As requested in the SNPRM, the following are responses to specifically posed questions:

Figure One

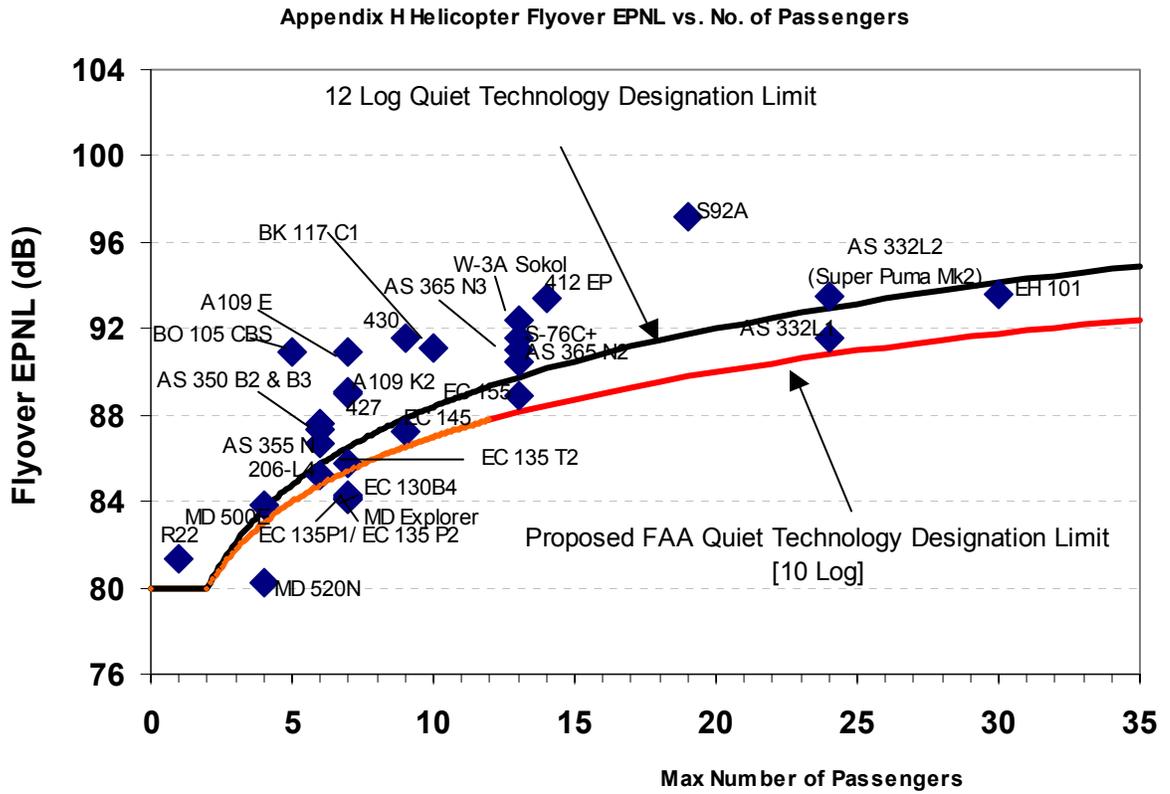
- It is felt that the use of certificated noise level as the basis for establishing noise efficiency is reasonable. However, HAI *disagrees* with the “10log” slope of the curve used to delineate those aircraft above two seats that meet the QTD limitation for two reasons: 1) It eliminates advanced derivative aircraft; and, 2) It will eliminate all recent low noise designs in the intermediate and large categories (e.g., EC155 and EH-101), and will become increasingly difficult to meet by larger helicopters (which contradicts the intended goal of the “QTD” SNPRM to foster use of quieter, higher passenger helicopters). 12log is a reasonable compromise between the proposed 10log slope (the generally accepted scaling of traditional helicopter technologies with gross weight) and the 13 to 17log slope scaling with gross weight demonstrated by current technology NOTAR and Fenestron aircraft. A slope of 12log will provide economically reasonable and achievable technical goals for future designs. The 12log slope would allow some of the new technology aircraft that have been developed in recent years to fall under the proposed QTD. In effect, the proposed QTD 10log slope actually eliminates more modern and technologically advanced aircraft. For example, for larger aircraft, the EH101 is known to have a large amount of noise reducing technologies and this aircraft falls outside of the 10log slope of the QTD curve. The new EC145 operates 6.7dB under the ICAO limits, yet fails the 10 log “QTD” test. The proposed 10log slope also eliminates more modern and technologically advanced *derivative* aircraft and keeps the earlier versions as meeting the QTD. For example, the EC135T2 fails the 10log QTD test, although it is a more advanced derivative than its predecessor model, which passes the QTD test.

Aircraft that have better operating performance and lower direct operating costs as well as those aircraft that have been developed and derived from other models for those purposes, should not be arbitrarily eliminated. Figures one and two illustrate the Appendix H and Appendix J Helicopter Flyover Noise Levels (in EPNL and SEL respectively) plotted against the maximum number of passenger seats. The 10log slope proposed in the SNPRM is shown in relation to the proposed 12log slope.
